н Н	SECTION 4.11 (FLOOD ZONE) SPECIAL PERMIT AND SECTION 12.9 MINOR CHANGE FOR CONSTRUCTION OF AN ADDITION FOR LABELLA SALON MEETING DATE : MARCH 19, 2024
PUBLIC HEARING #1 3/19/24 AGENDA	• The applicant is proposing to construct a 408 sq ft addition to the existing 2111
Address: 244 Naubuc Ave To: Town Plan and Zoning	 sq ft existing building used by LaBella Salon at 244 Naubuc Ave. The property is located in the Flood Zone and requires a Section 4.11 Flood Zone Special Permit and 12.9 Minor Change for the proposed addition. The property is 3.13 acres zoned Town Center Mixed Use (TCMU) and Flood Zone with 1.6 acres of wetland to the north and east that are protected by pro-
Commission From:	 posed conservation easement. ASDRC reviewed the proposed project at their regularly scheduled meeting on August 22, 2023. The Committee forwarded a favorable recommendation in their ASDRC Review Committee Report dated 8/22/23.

MOVED, that the Town Plan & Zoning Commission approve the applications of 244 Naubuc Ave, LLC for a 4.11 Flood Zone Special Permit and a Section 12.9 Minor Change – for construction of an addition to LaBella Salon – 244 Naubuc Ave – Town Center Mixed Use & Flood Zones,

RU L-2

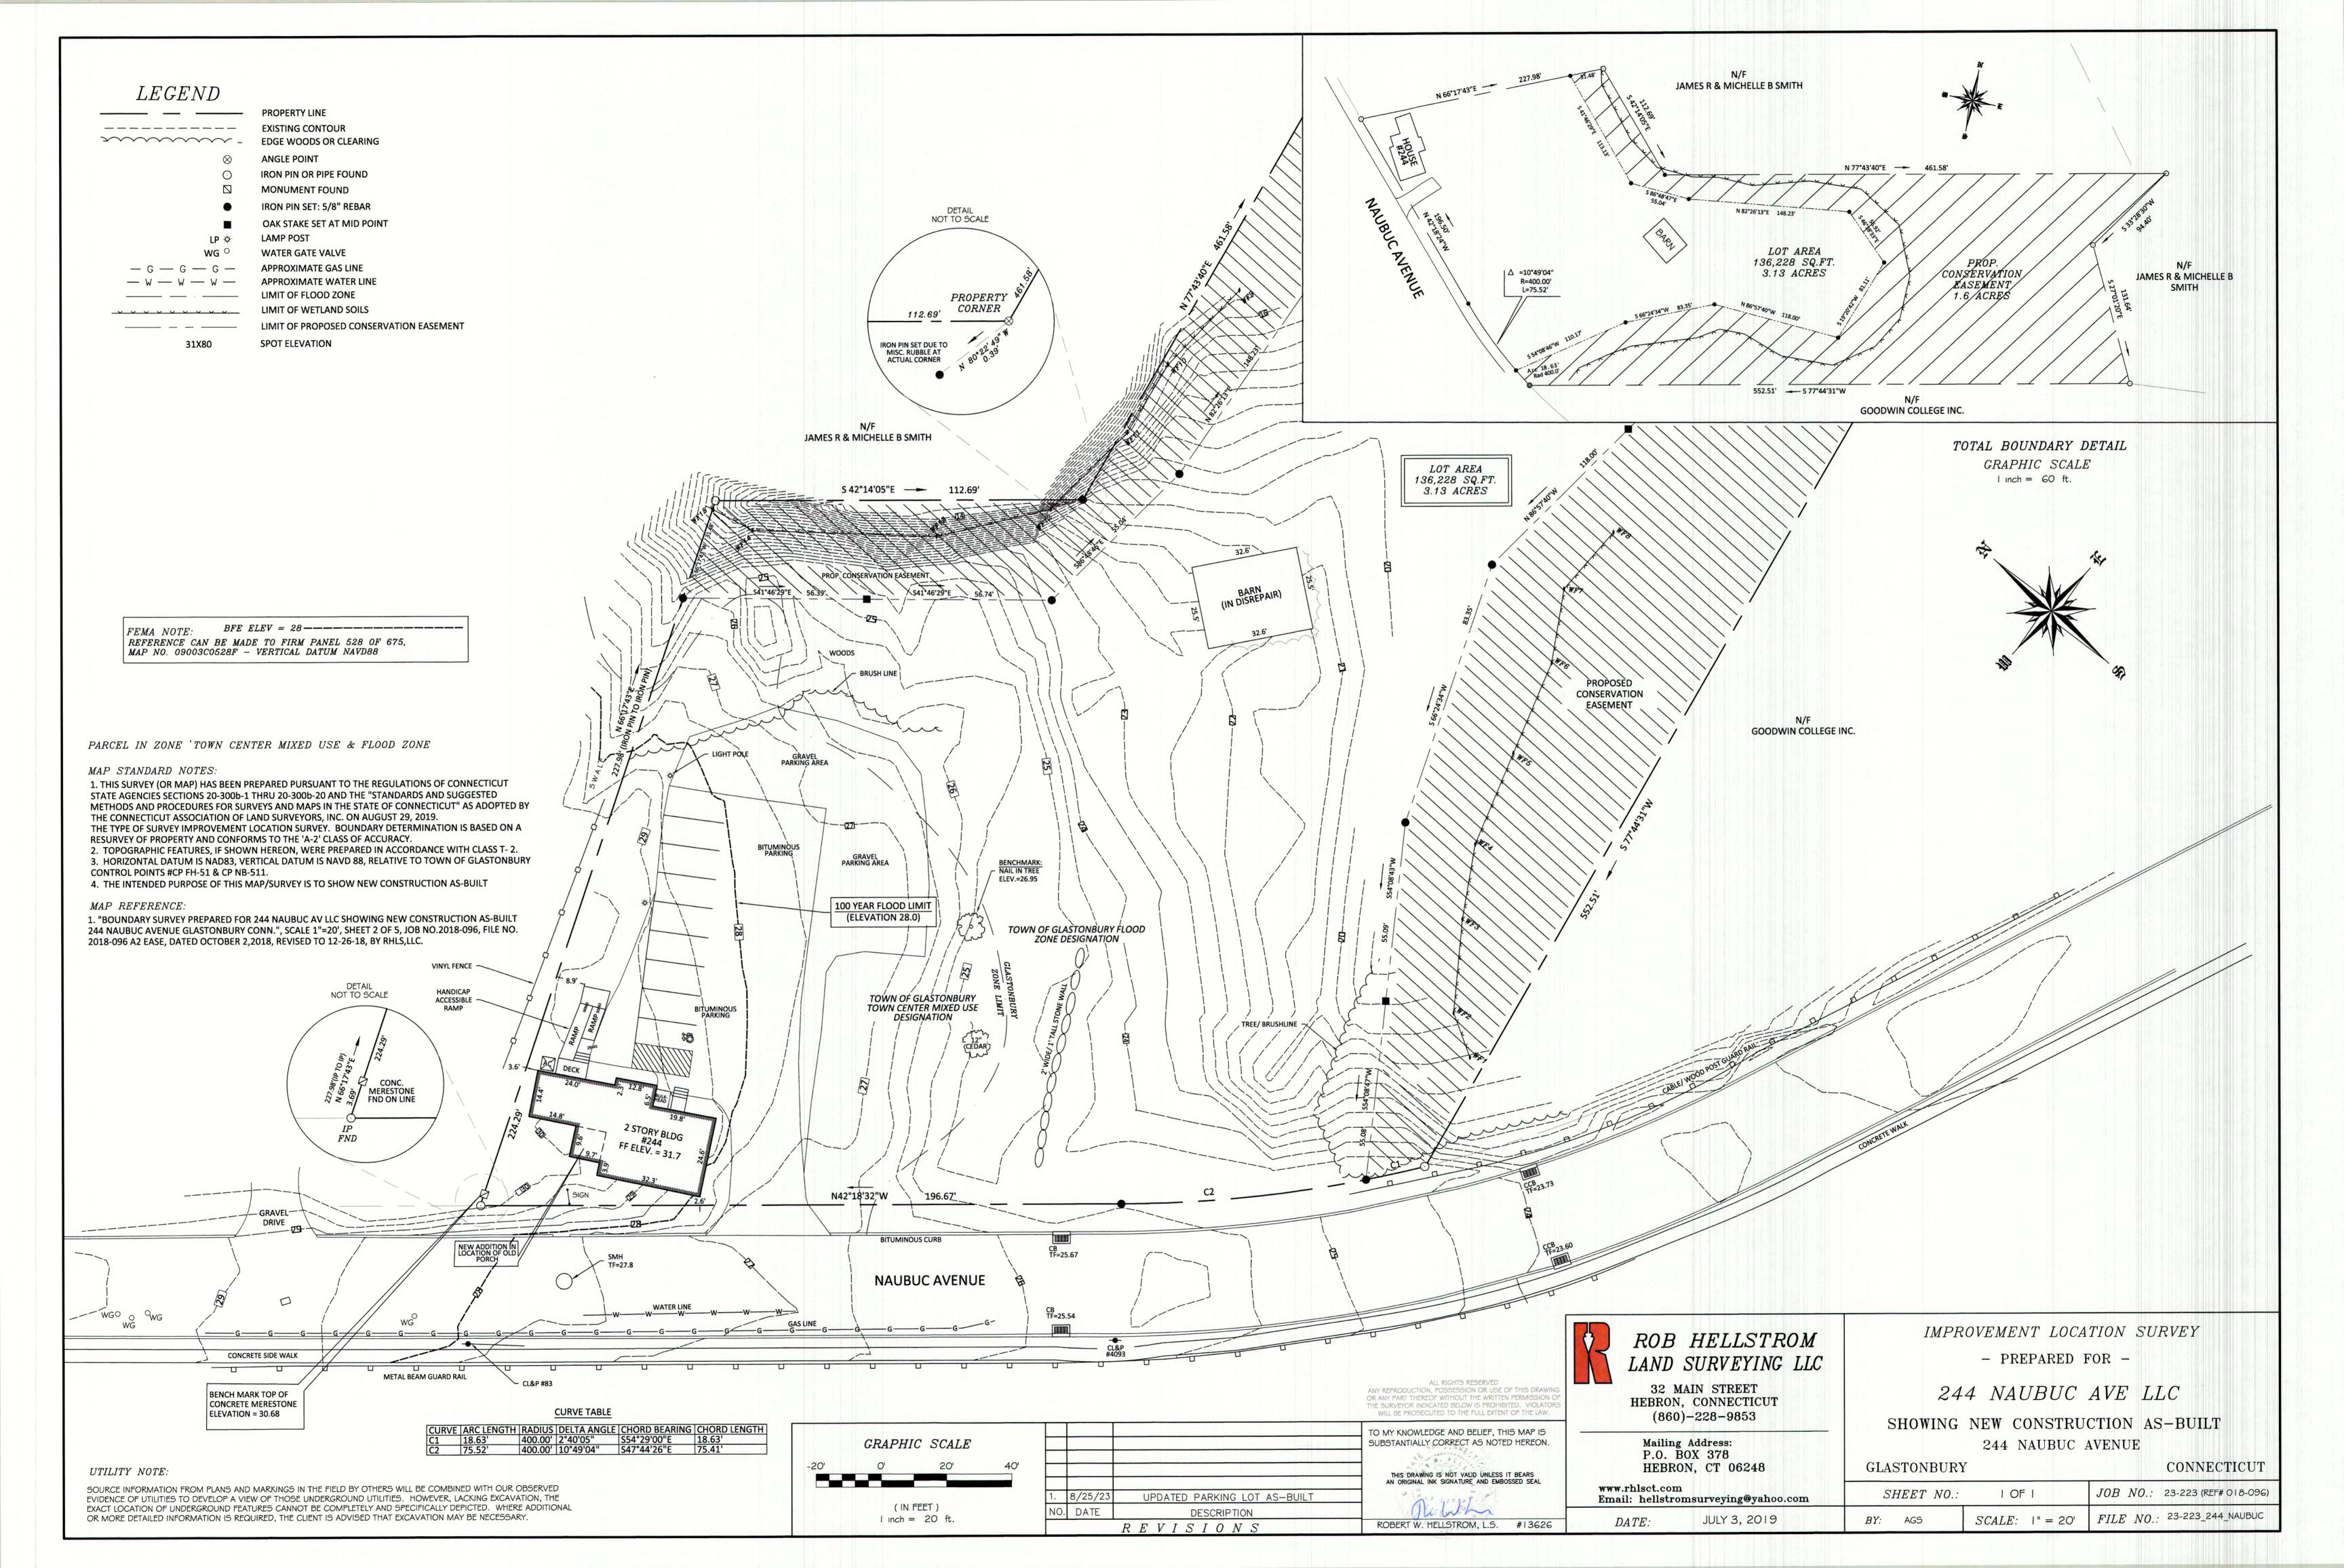
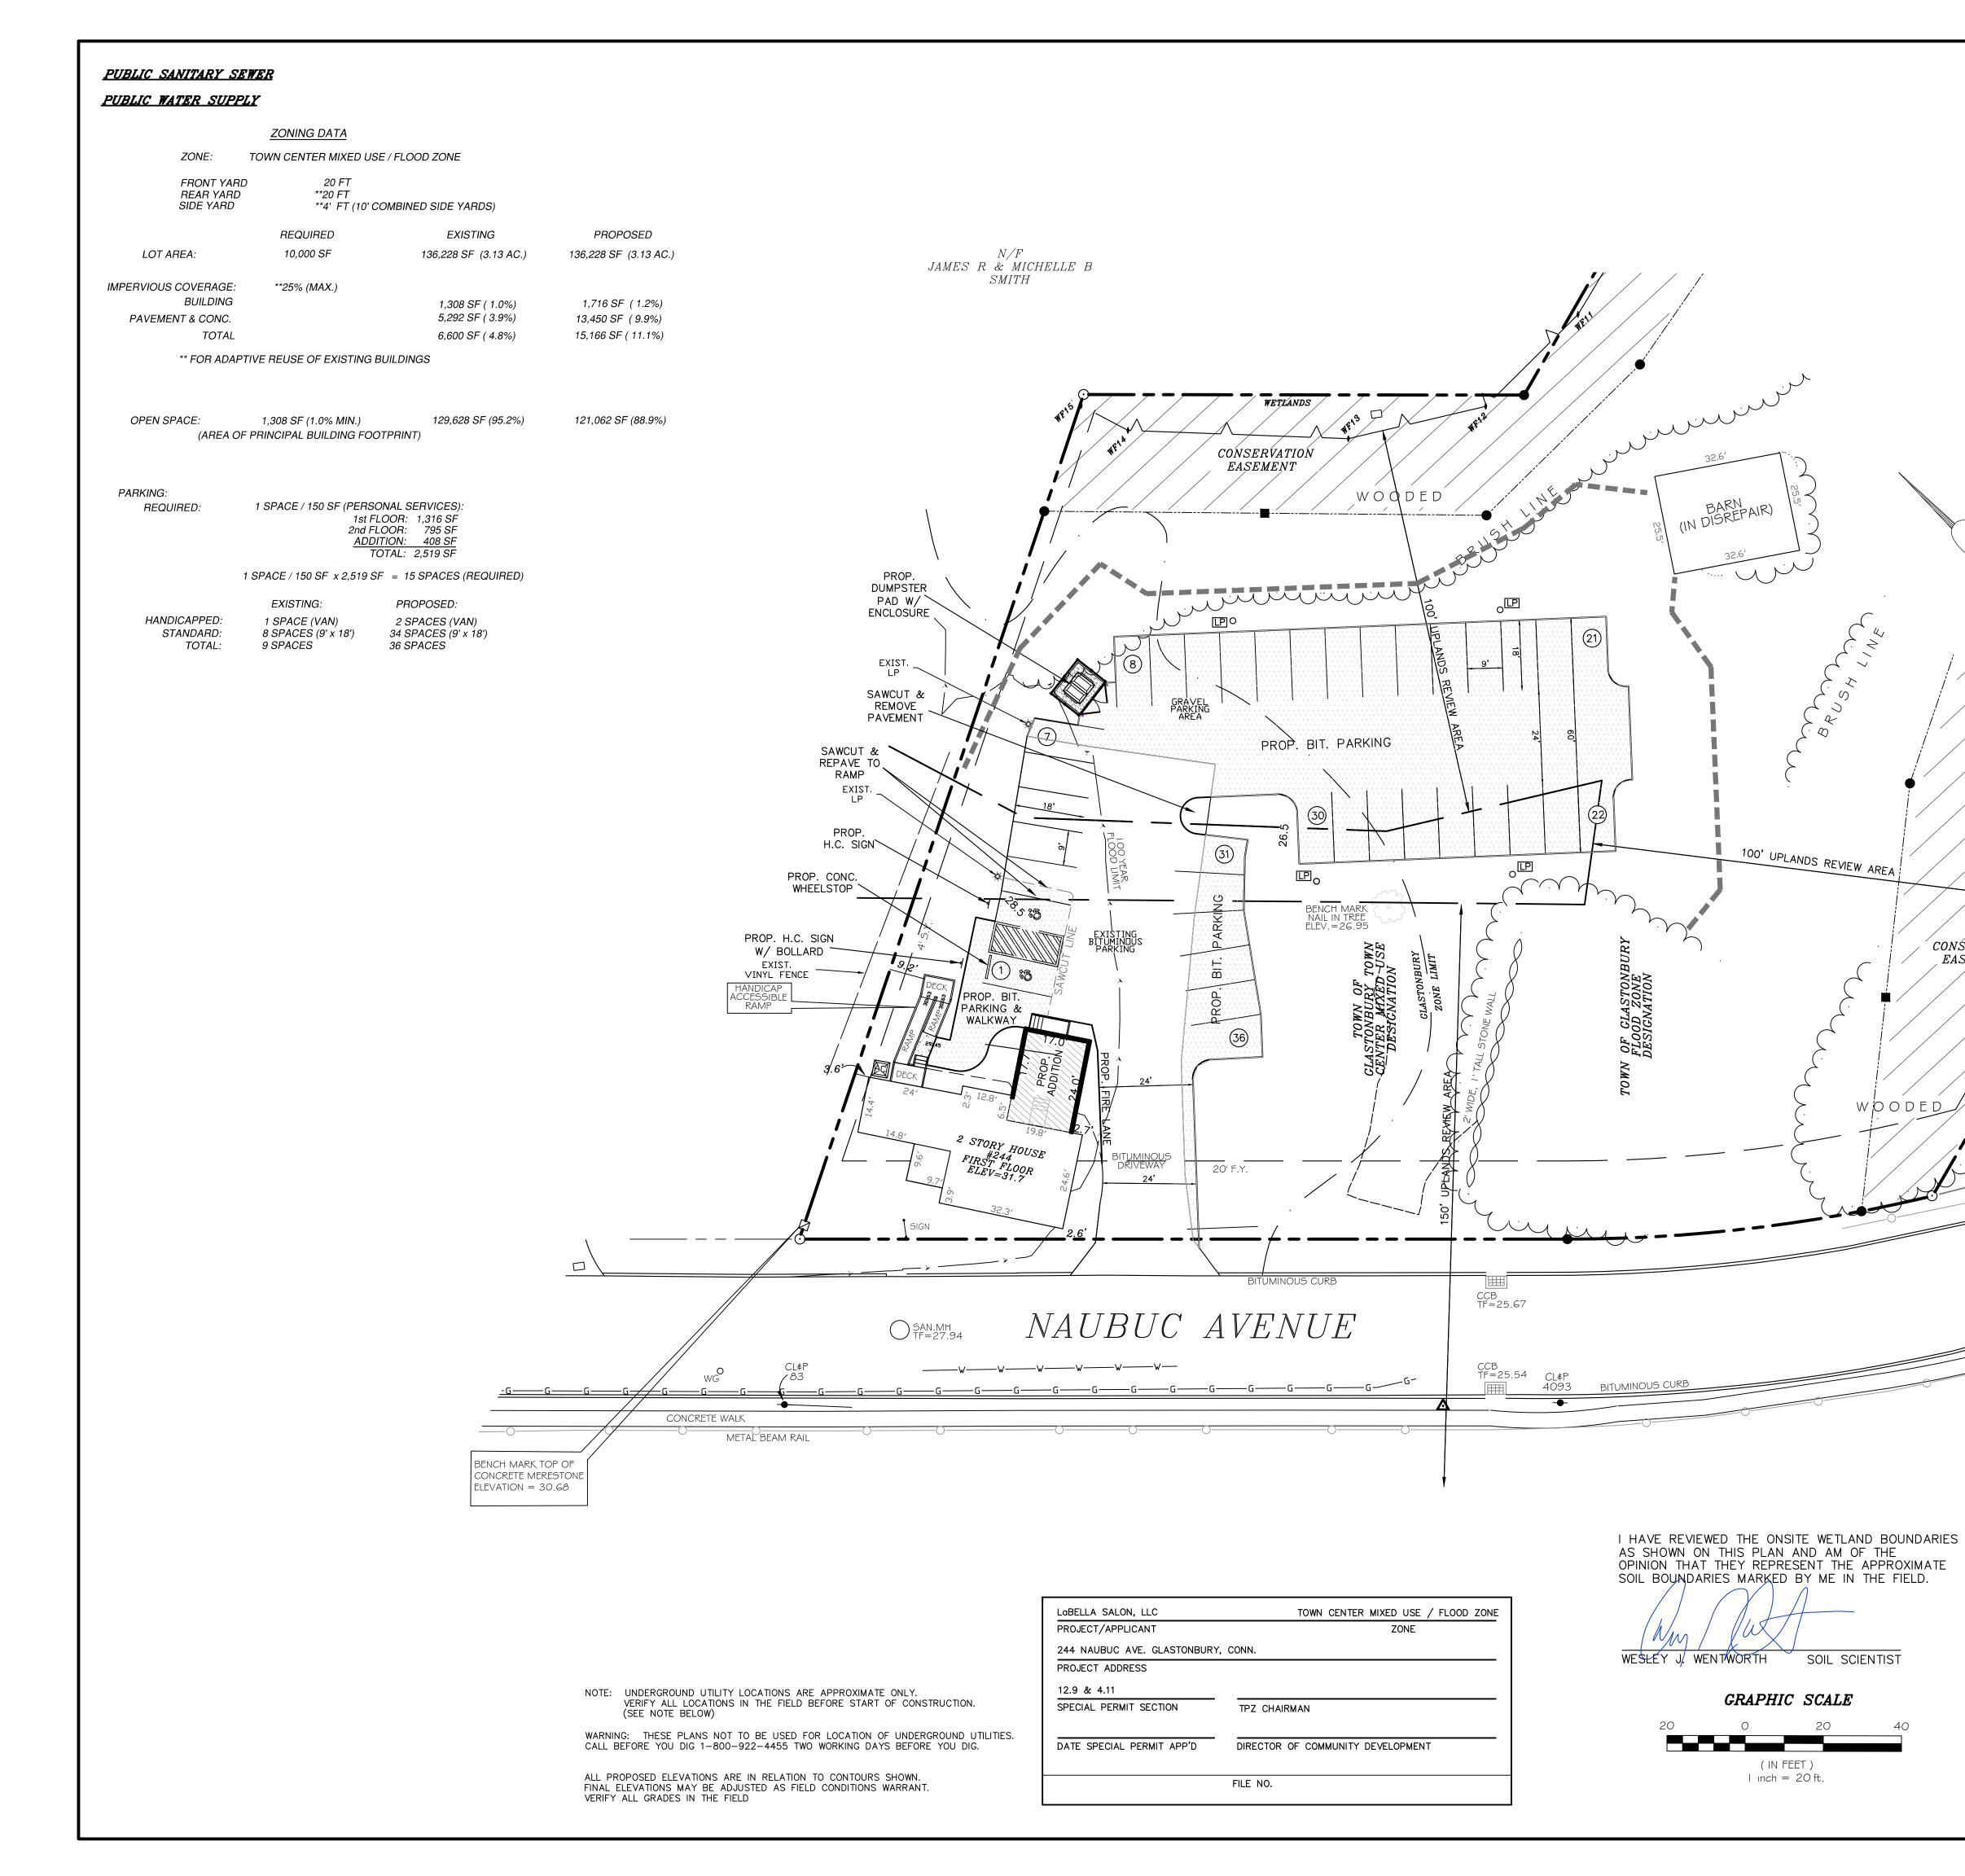
- 5. Revise finalized plans to address following:
 - Change rear yard setback 30 feet
 - Change side yard setback combine width 20 feet, with minimum 8 feet on one side. (add note for existing non-conformity for side and front yard setback)

- Change Building Coverage 20%
 - Add lot frontage
 - Add Sheet L3 to Cover Page
